LIBERTY TREE ACADEMY – PHASE II IMPROVEMENTS
FINAL DRAINAGE REPORT

PPR-18-023

Liberty Tree Academy – Phase II Improvements
Final Drainage Report

Figure 2.
National Resources Conservation
Service (NRCS) Soils Map

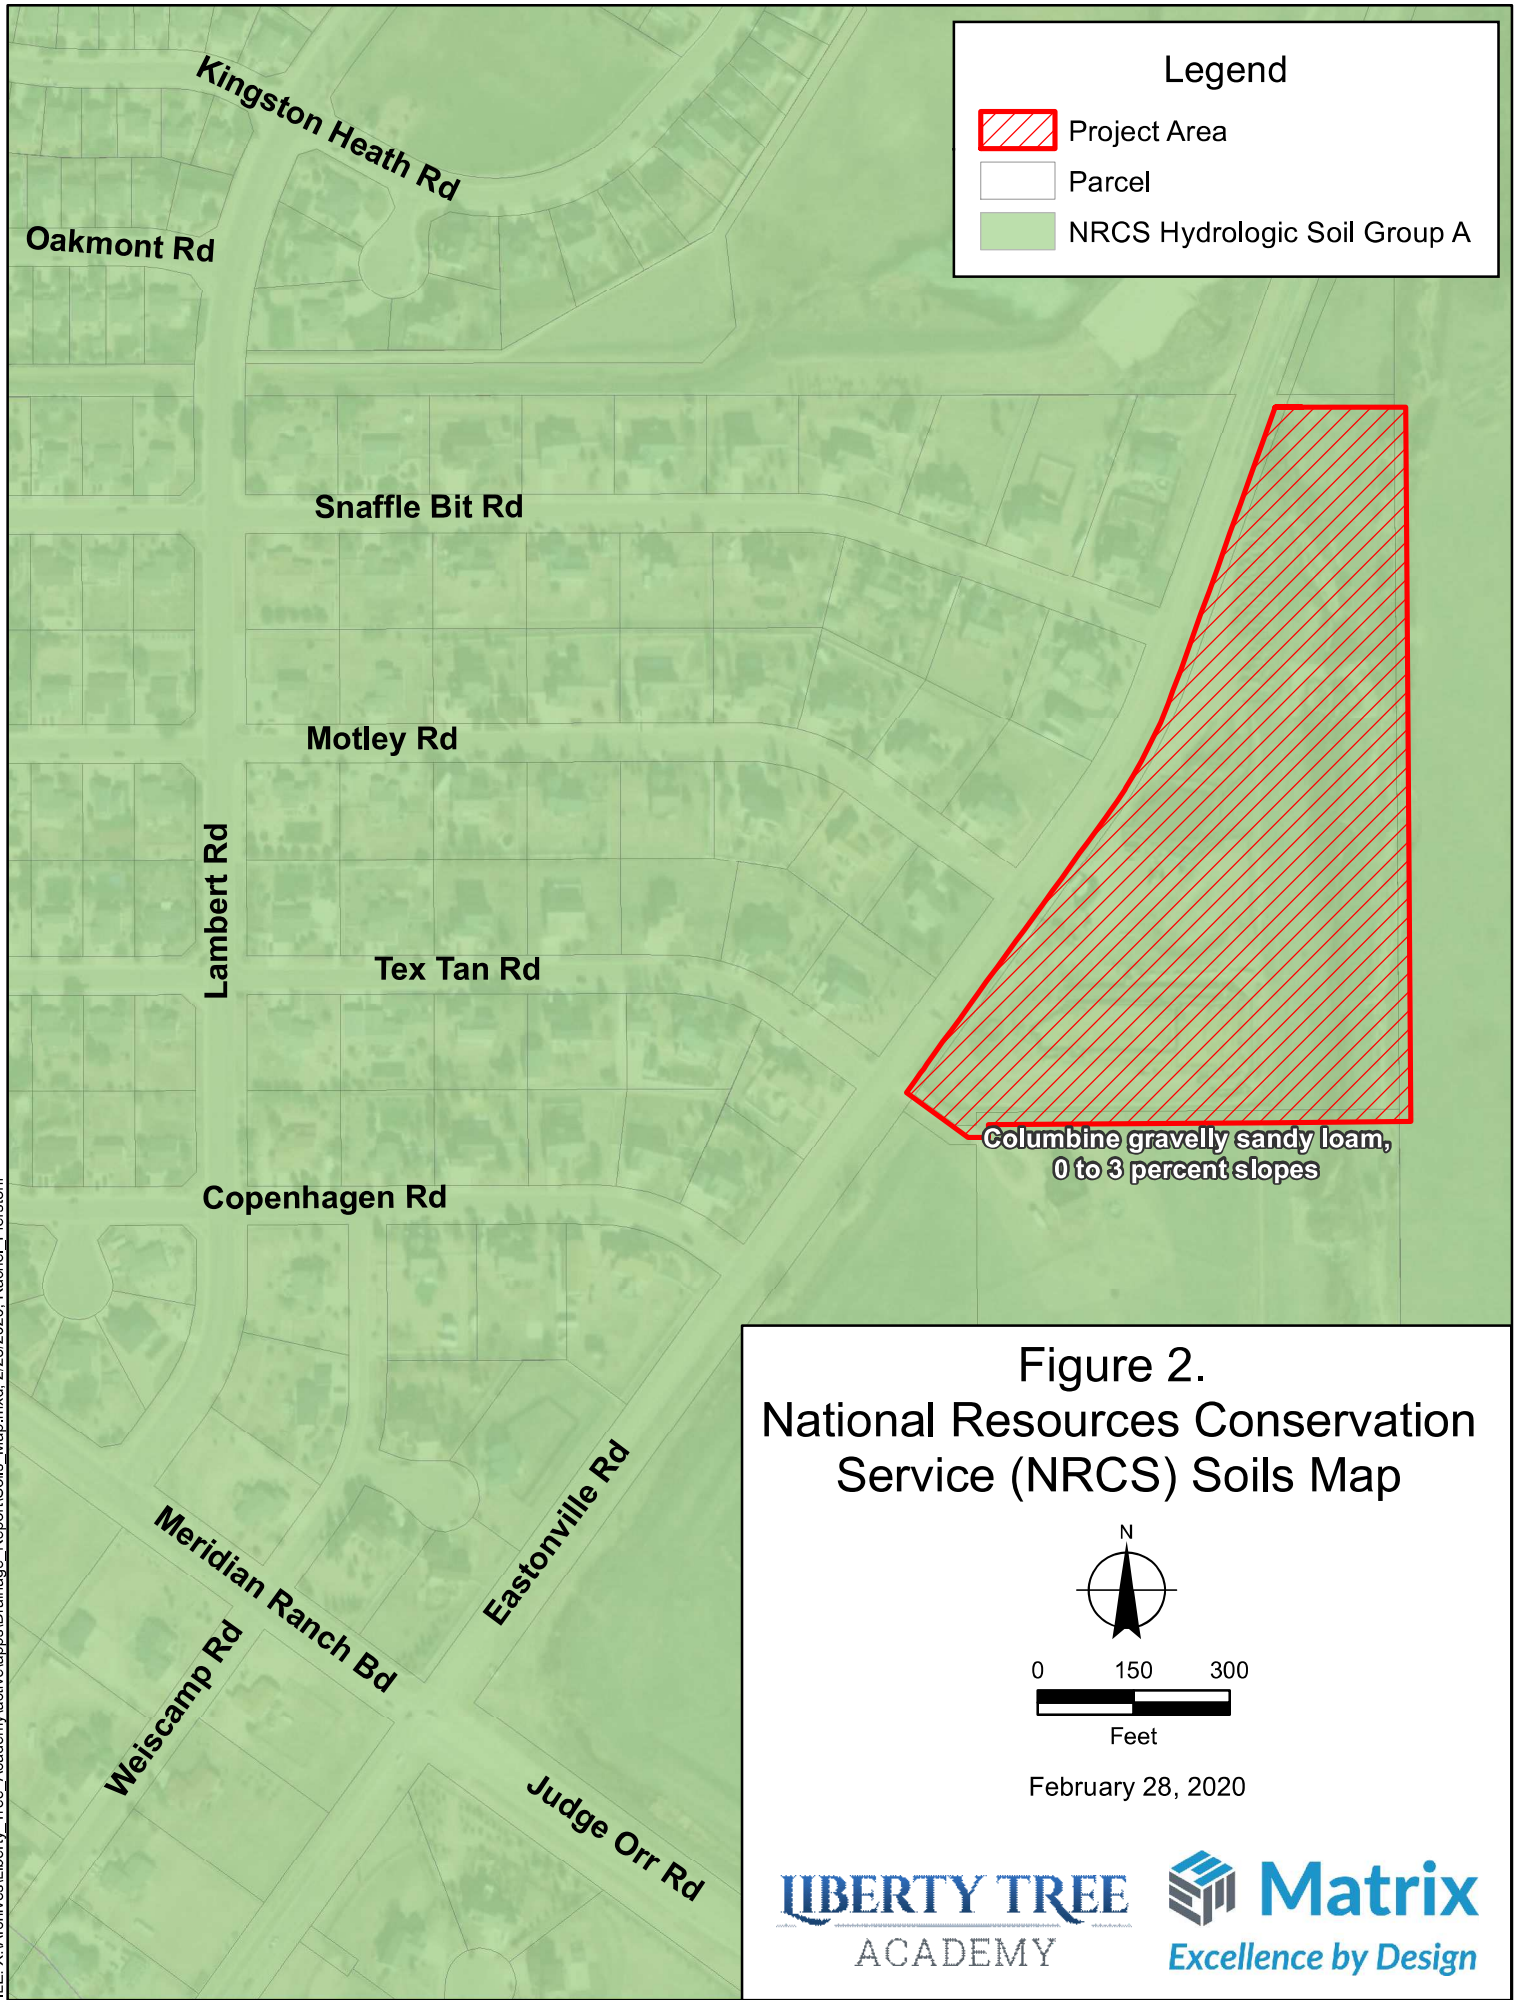
The previously approved site development plan indicated an irrigation system at the landscaped areas. Revise the text accordingly.

Figure I-1. BMP Requirements Flowchart for New Development and Redevelopment Sites - For Selecting Post-Construction BMPs in Compliance with El Paso County's Stormwater NPDES Permit

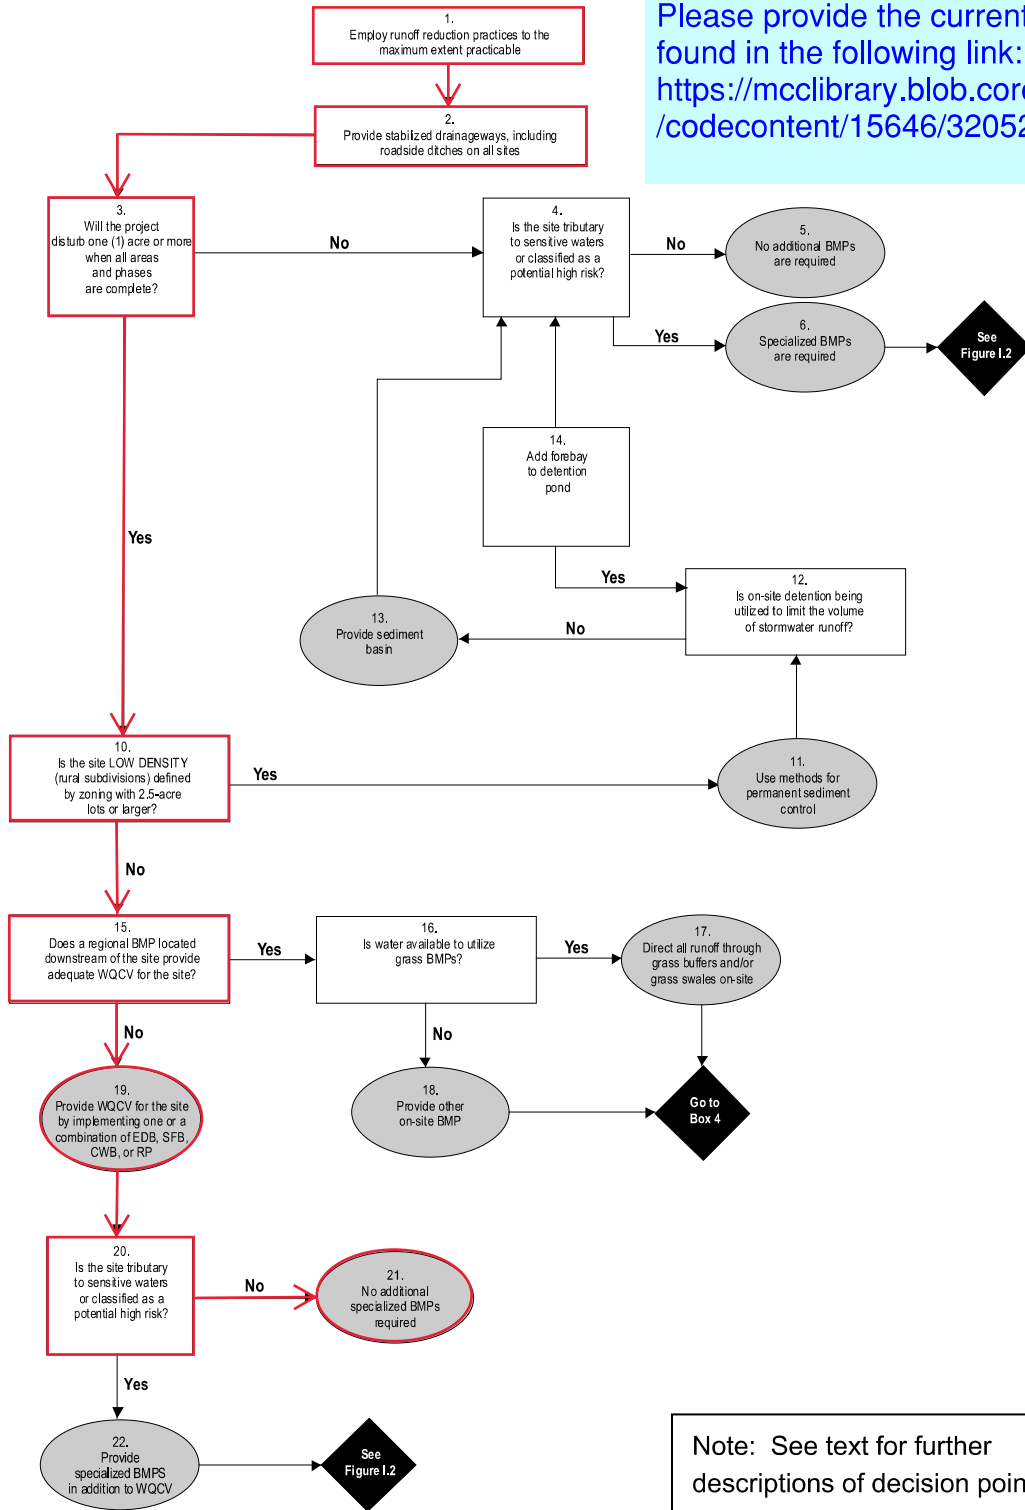
Please provide the current flowchart. It can be found in the following link:
<https://mcclibrary.blob.core.usgovcloudapi.net/codecontent/15646/320527/Fig1-1.png>

LIBERTY TREE ACADEMY
DRAINAGE REPORT
PHASE II IMPROVEMENTS
FIGURE A-1
EXISTING DRAINAGE PLAN

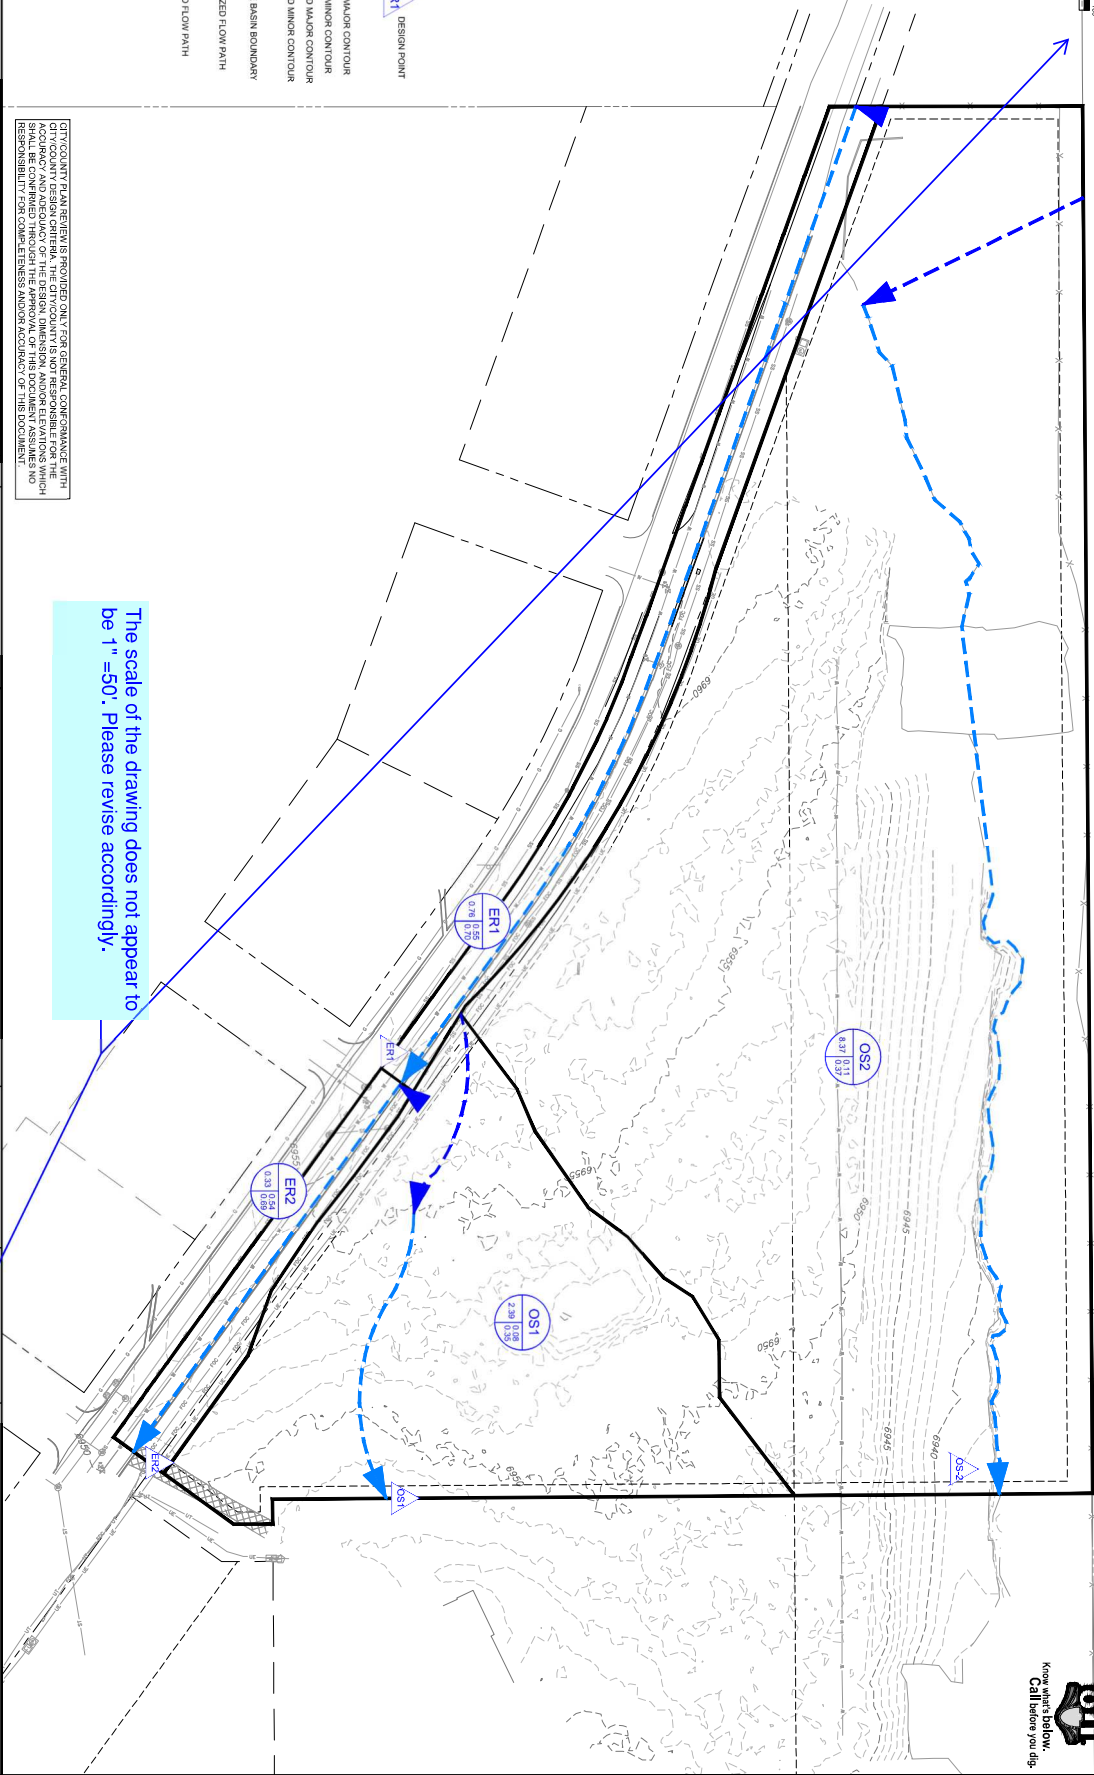
The scale of the drawing does not appear to be 1" = 50'. Please revise accordingly.

POND OUTLET & SPILLWAY PLAN & PROFILE		LIBERTY TREE ACADEMY	
DESIGNED BY	SCALE	PROJECT NO.	DATE
ACR	1"=20'	1896-001	8/20/2018
SKZ	1"=20'	1896-001	8/20/2018
CHKD BY	1"=20'	1896-001	8/20/2018

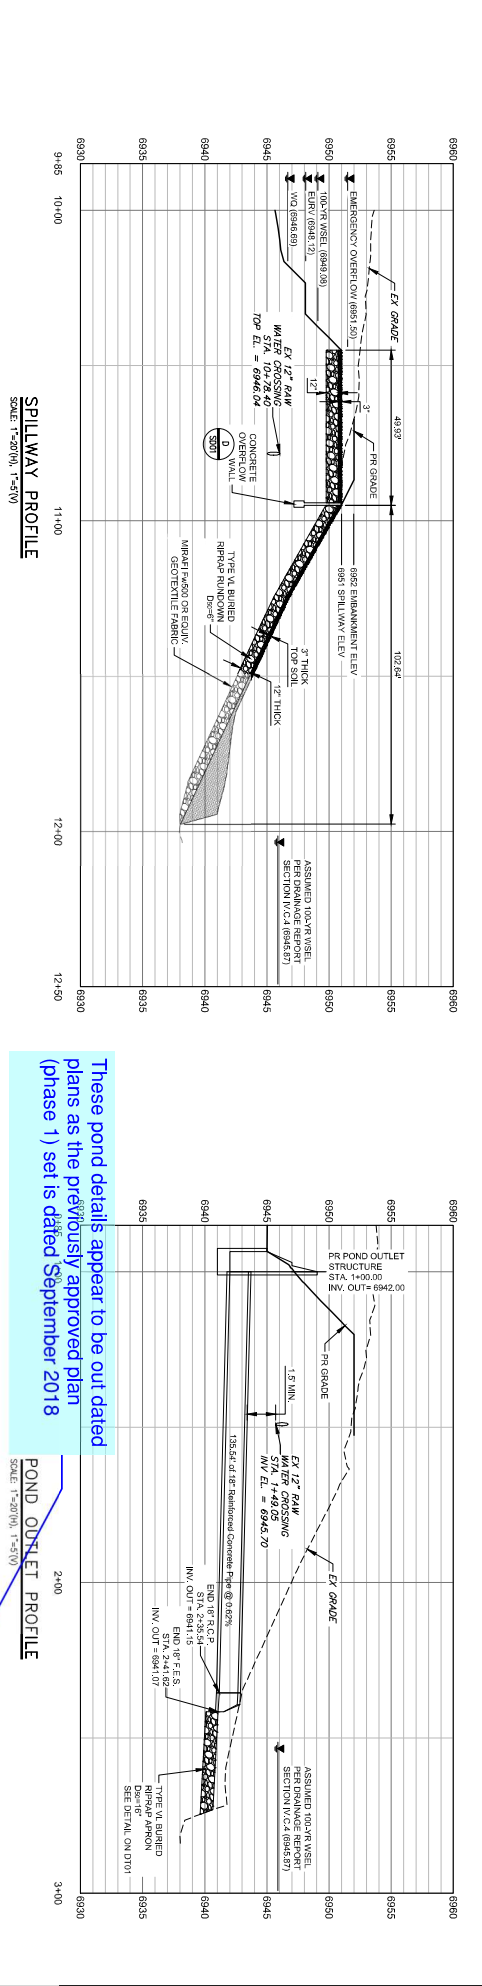
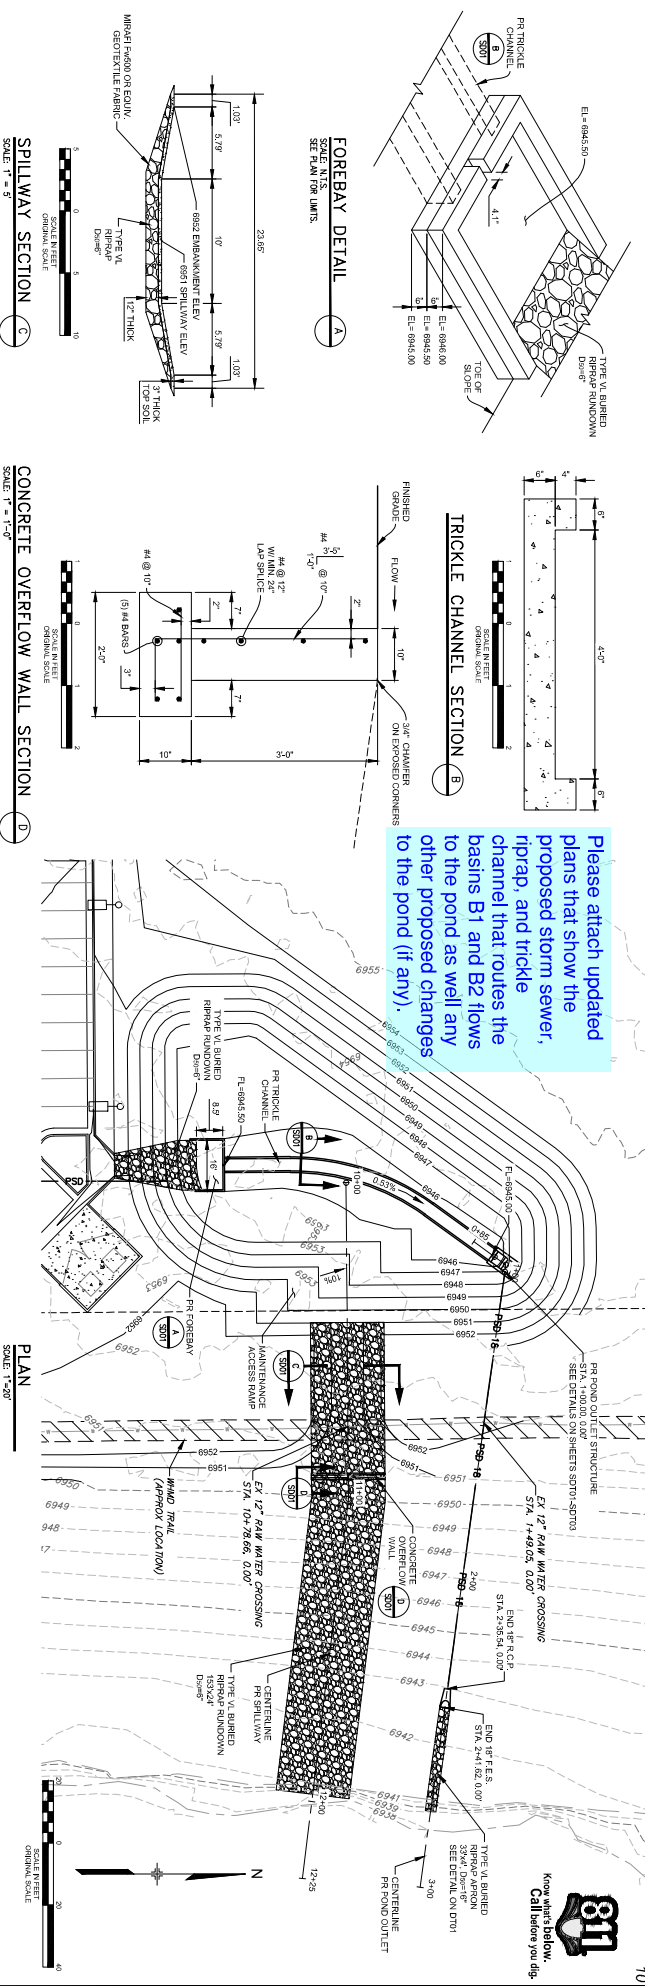
Please attach updated plans that show the proposed storm sewer, riprap, and trickle channel that routes the basins B1 and B2 flows to the pond as well any other proposed changes to the pond (if any).

Spillway Section

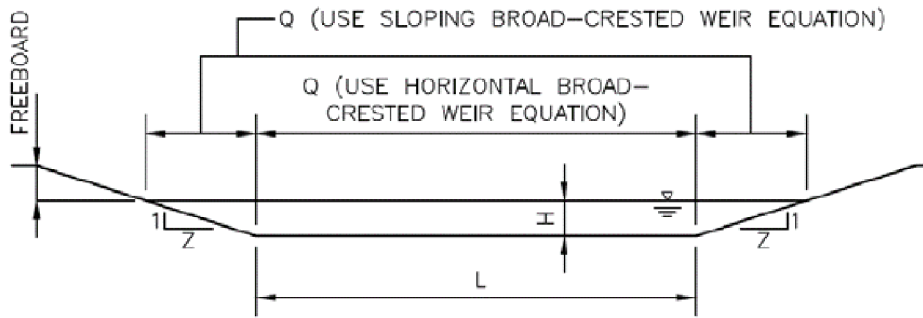
See previous comment regarding the crest length. Additionally the next page indicates 10 ft
